Subject: Issuance of Amendment No. 90 to Facility Operating License NPF-5 - Edwin I. Hatch Nuclear Plant, Unit 2 (TAC 66471)

AMENDMENT NO. 90 TO FACILITY OPERATING LICENSE NPF-5, EDWIN I. HATCH, UNIT 2

SAFETY EVALUATION BY THE OFFICE OF NUCLEAR REACTOR REGULATION

EDWIN I. HATCH NUCLEAR PLANT, UNIT 2

FIGURE 3.1.5-1 SODIUM PENTABORATE SOLUTION VOLUME VERSUS CONCENTRATION REQUIREMENTS

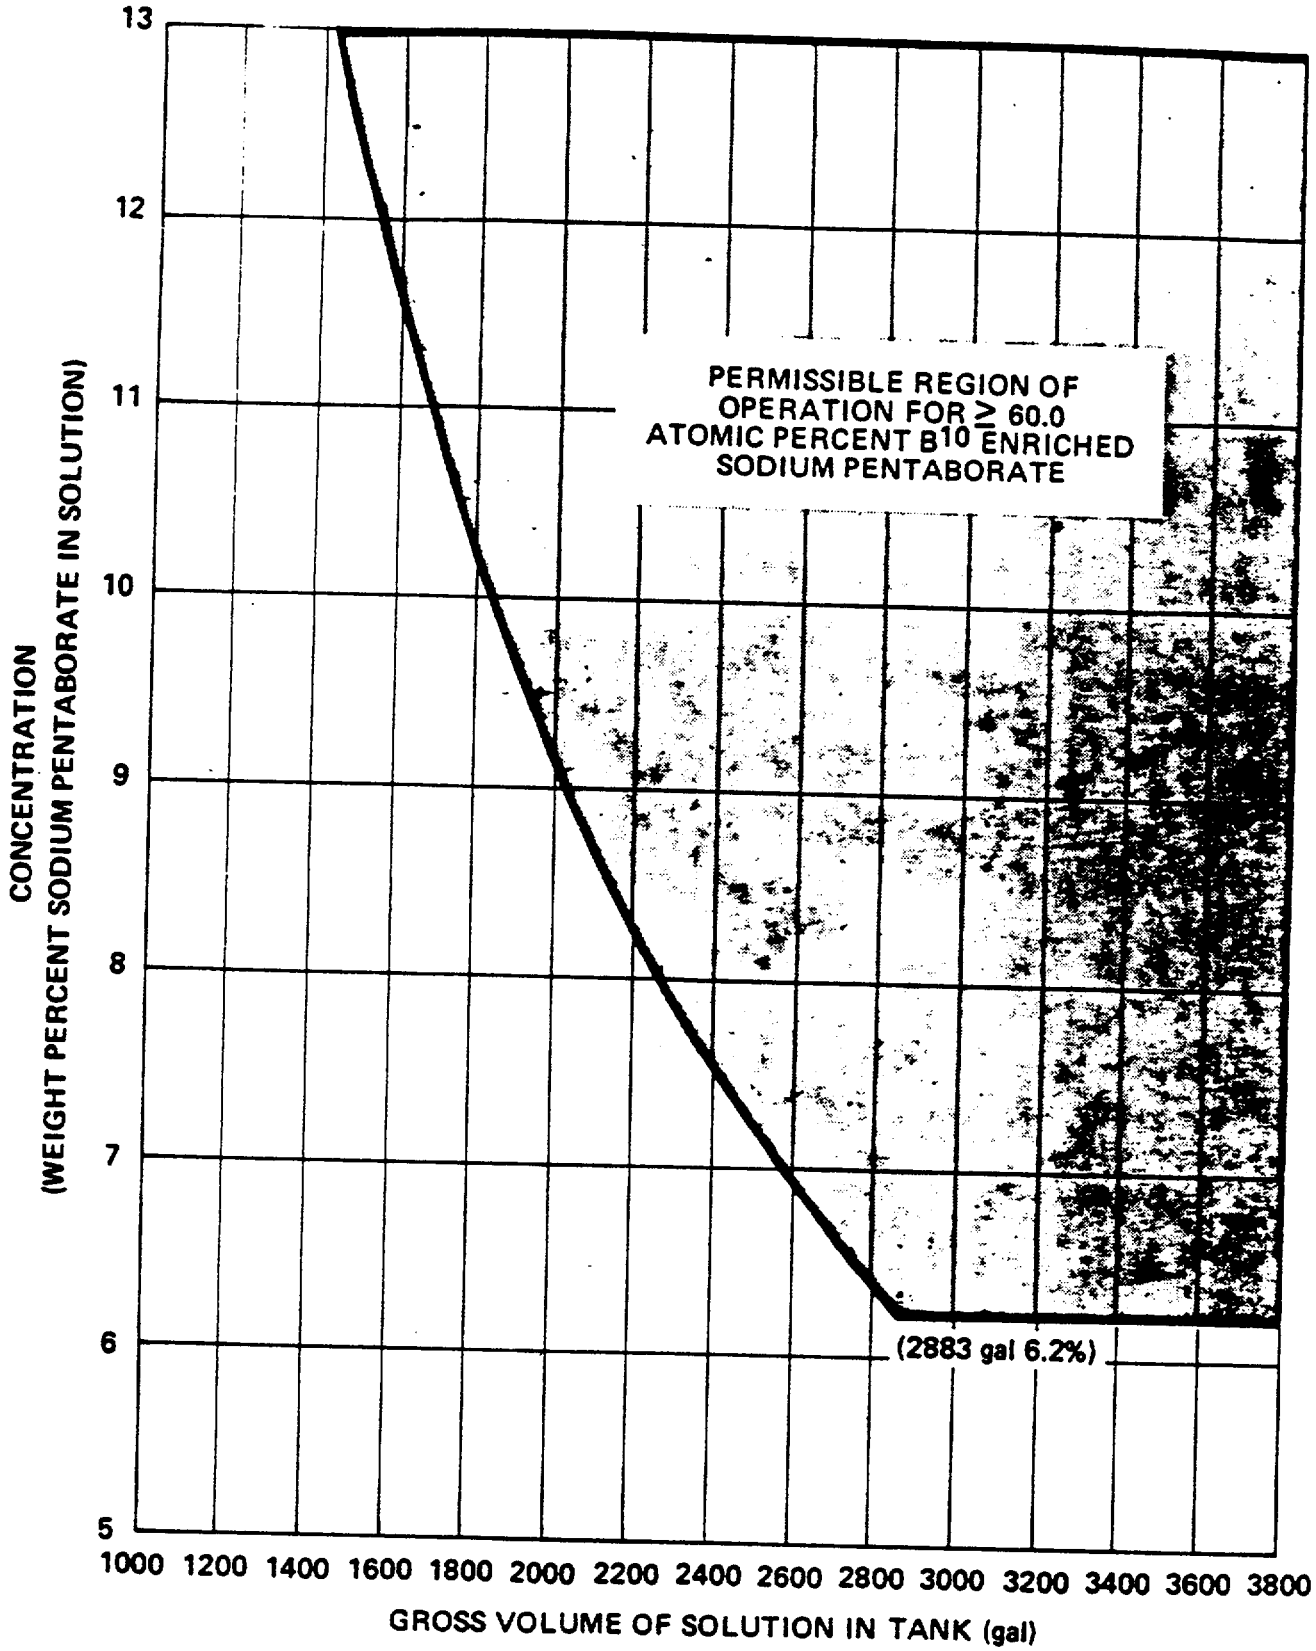
The existing TS 4.1.5 sets limits on the minimum volume of sodium pentaborate solution and the minimum weight of sodium pentaborate in the solution. TS Figure 3.1.5-1 sets minimum solution temperature limits as a function of solution concentration. The licensee proposes to replace TS Figure 3.1.5-1 with a new Figure 3.1.5-1 which establishes an operating range of acceptable solution volumes as a function of the concentration of sodium pentaborate in the solution, and a new Figure 3.1.5-2 which sets an operating range of minimum solution temperatures as a function of sodium pentaborate concentration. The text of TS 3/4.1.5 would be revised to reference the limits shown on these two new figures. The revised minimum solution volume is set at 2,883 gallons when using a 6.2 weight percent solution of sodium pentaborate enriched to 60 percent in the Boron-10 isotope. This volume and concentration maintains the same margin of safety as in the existing TS. For higher concentrations of sodium pentaborate, smaller volumes of solution are required, as displayed on TS Figure 3.1.5-1. The minimum solution temperature required by the graph on TS Figure 3.1.5-2 maintains a constant 10°F margin above the saturation temperature for the solution concentration. The two new figures are identical to those previously approved for the Unit 1 TS (Reference 2). In conjunction with the revisions to the text of TS 3/4.1.5, this approach establishes appropriate limits on the sodium pentaborate solution and is acceptable.

The volume limits in Figure 3.1.5-1 are calculated such that for a given concentration of sodium pentaborate, the tank contains a volume of solution adequate to bring the reactor to a cold shutdown, with margin. These volume limits are based on gross volume and account for the unusable volume of solution in the tank and suction lines.
